St Marys Site Audit Report and Site Audit Statement for RAP

Sydney Metro Western Sydney Airport Station Boxes and Tunnelling Works

Project number	WSA-200-SBT
Document number	SMWSASBT-CPG-STM-SN100-EN-RPT-295367
Revision date	16 February 2024
Revision	00

SITE AUDIT REPORT REMEDIAL ACTION PLAN, ST MARYS STATION BOX AND TUNNELLING WORKS, SYDNEY METRO WESTERN SYDNEY AIRPORT

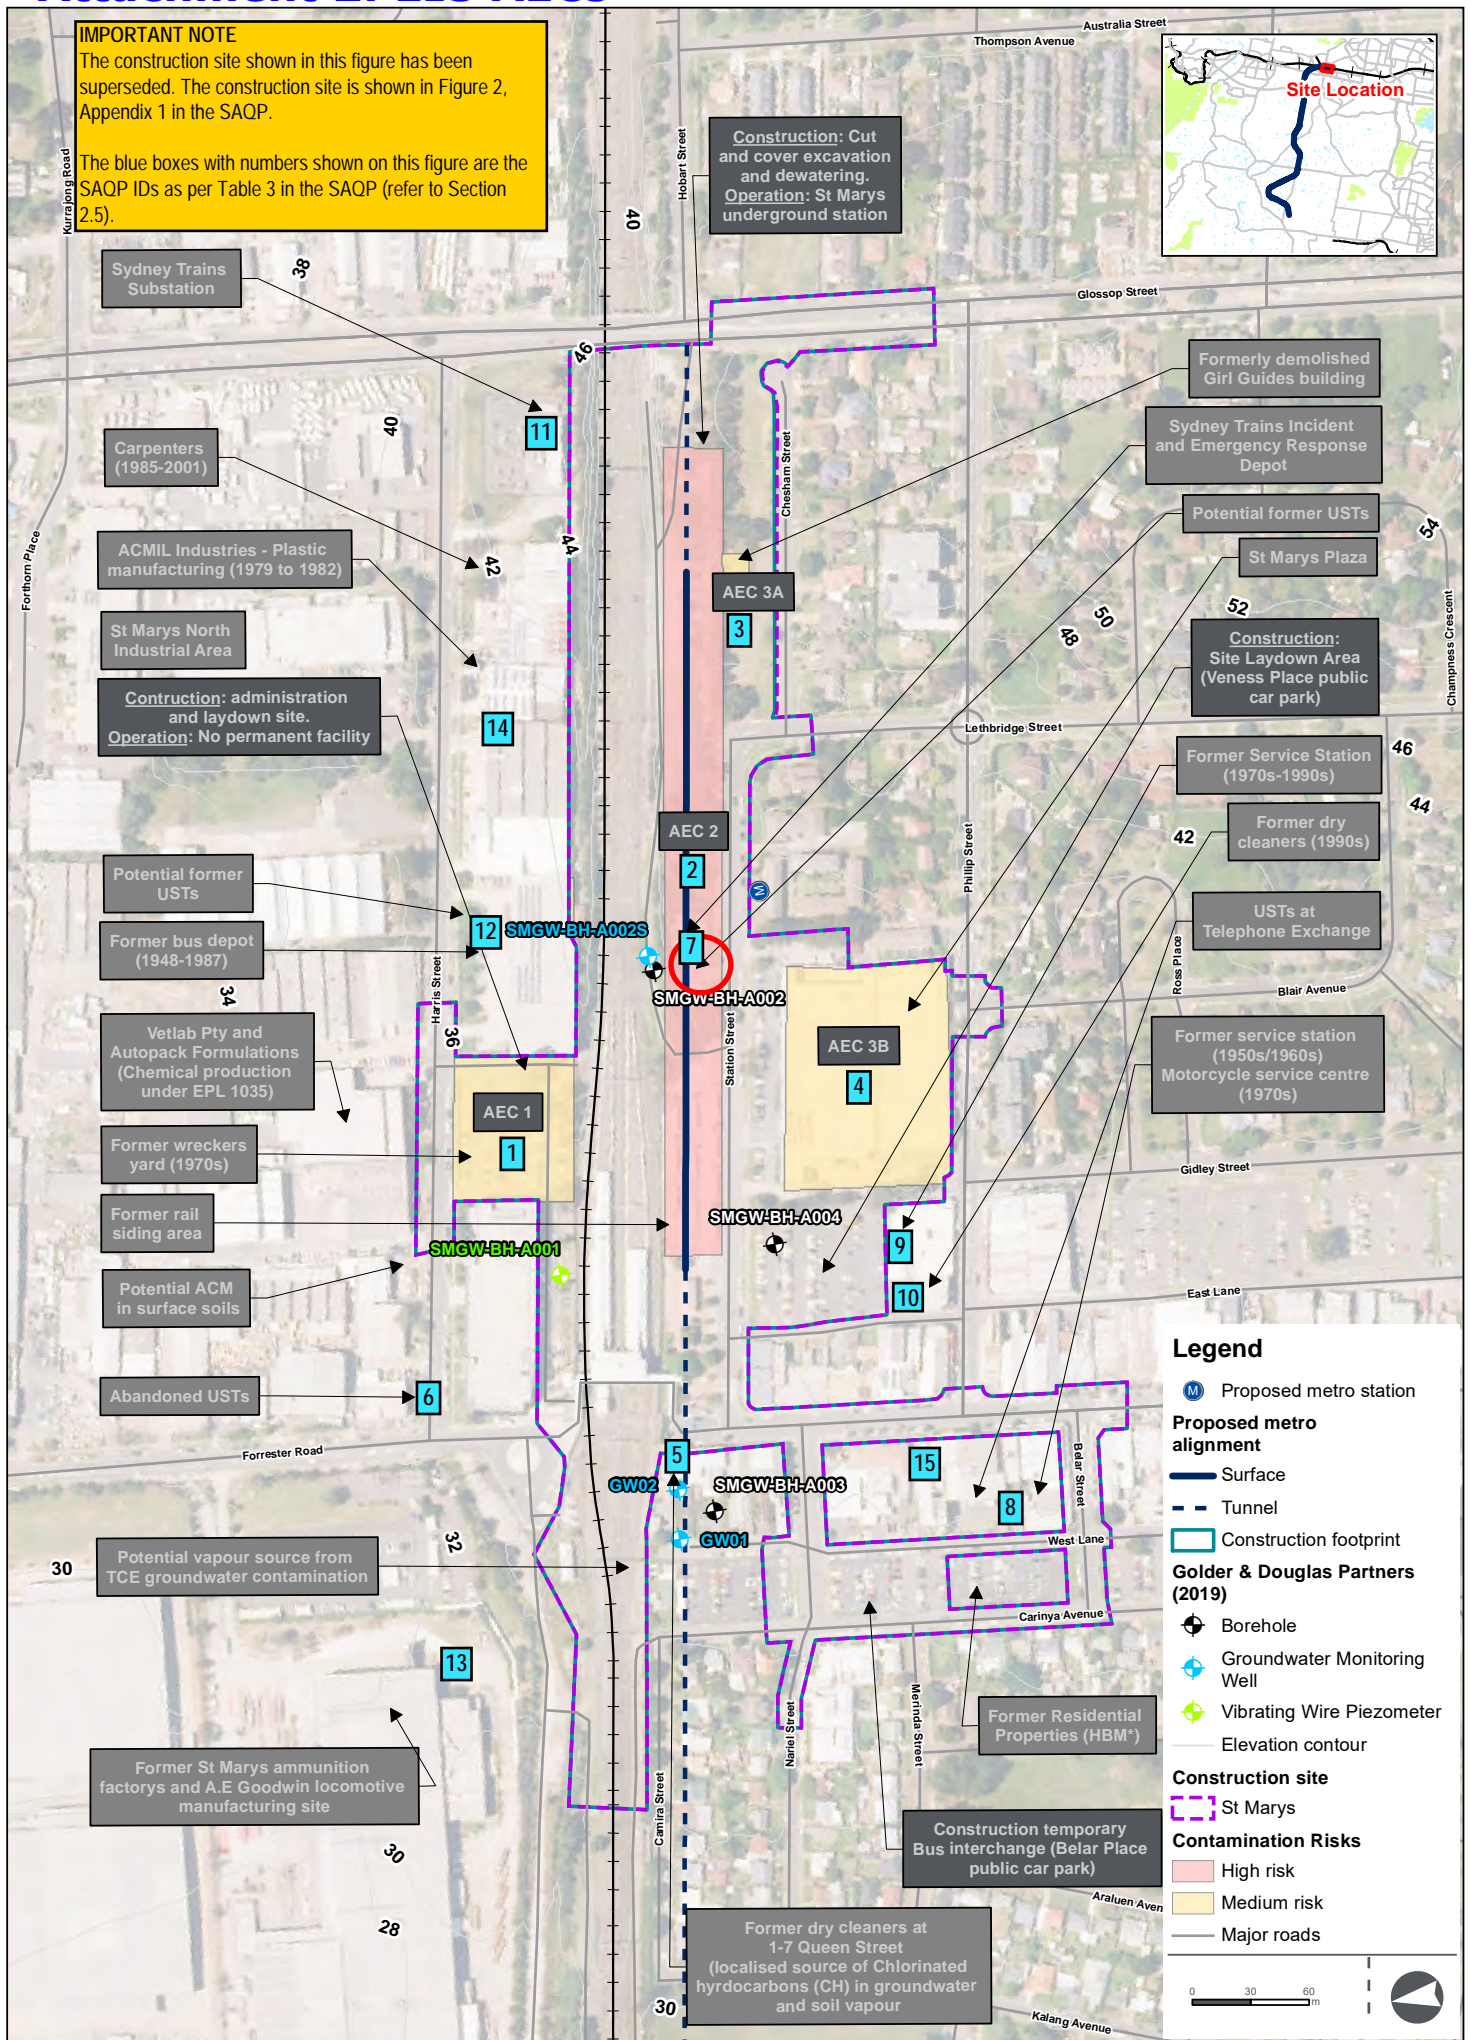
The site locality is shown on Attachment 1, Appendix A (note yellow SBT/site boundary on this attachment is incorrect). The site/Audit boundary is defined by the construction site boundary illustrated by the red outline in Attachment 13a and 13b, Appendix A. It is noted that other attachments to the SAR do not correctly show this boundary.
